Los Angeles County Department of Regional Planning

Permit: RPPL202306556 Project No. PRJ2023-004450 Zone: A-d16000

Address: 16236 BLACKHAWK ST, WOODLAND HILLS, CA 91364

SITE PLAN REVIEW

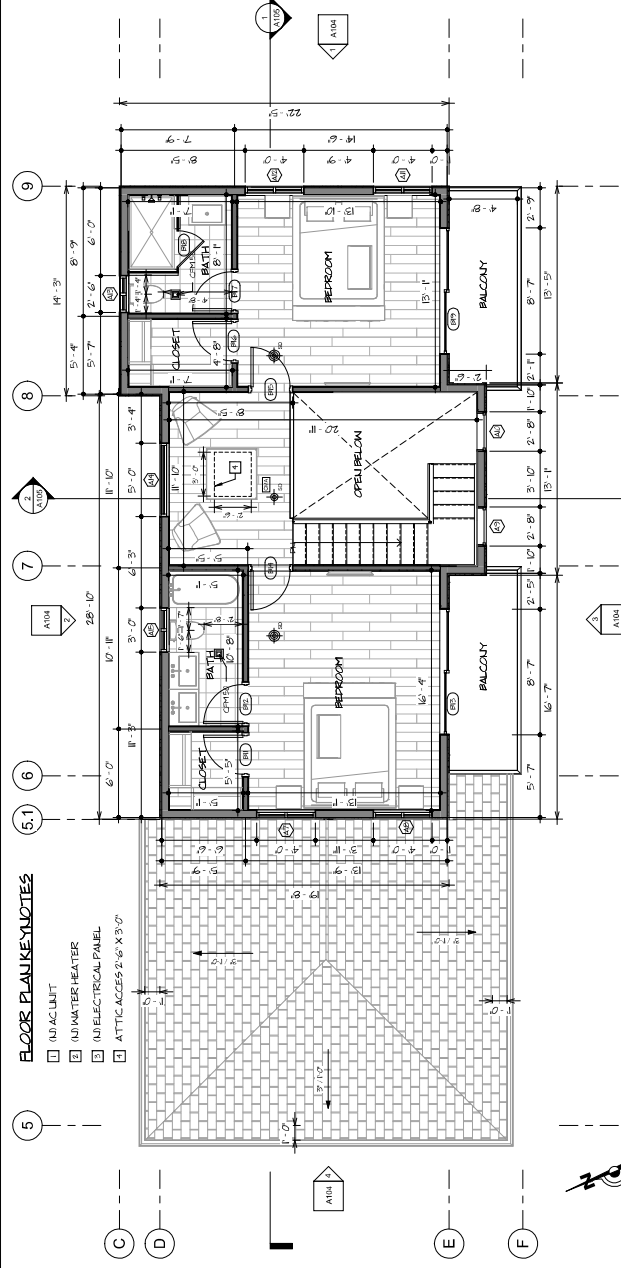
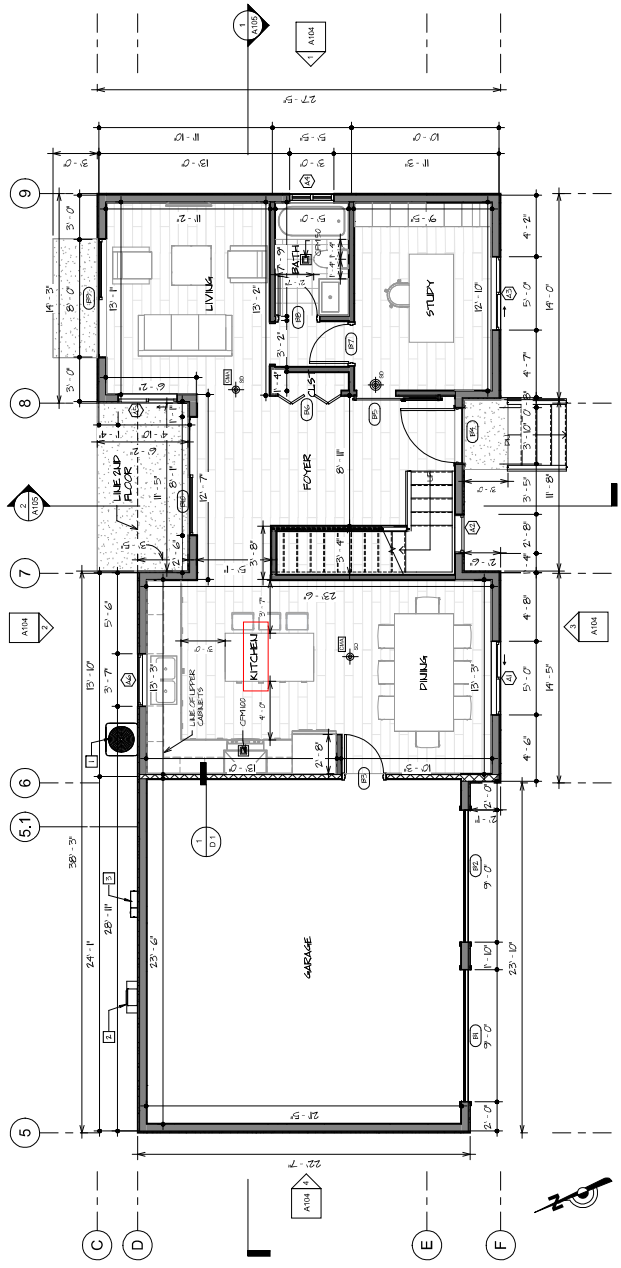
1. Pkg plan approved for a new, 1,506 sq. ft. two-story single-family residence with 4 bedrooms, 4 attached garages, a new kitchen, and two baths. The project includes a new 11' x 8' 6" x 8' 6" laundry with setbacks as shown on plans. Mainland fill over two trees in compliance with section 22.021 (Tree Planting) requirements of the Los Angeles County Zoning Code.

2. All tree removal and/or other impacts must be approved by Los Angeles County Public Works prior to the issuance of a Certificate of Compliance to combine 6 parcels into one that has been recorded for this property.

3. An informational Certificate of Compliance (COC) is required for this project. The COC will be submitted to the Department of Public Works pending on the issuance of the Certificate of Compliance.

4. The applicant shall submit a plan for the mitigation of impacts to the project to the Department of Public Works in accordance with the Green Building Program.

5. No trees are depicted on the plans and no encroachments or removals are authorized.

6. Green building and low impact development requirements may be applicable to the satisfaction of the Department of Public Works to the approval of additional DPR review and fees and may be subject to additional requirements of the Green Building Program.
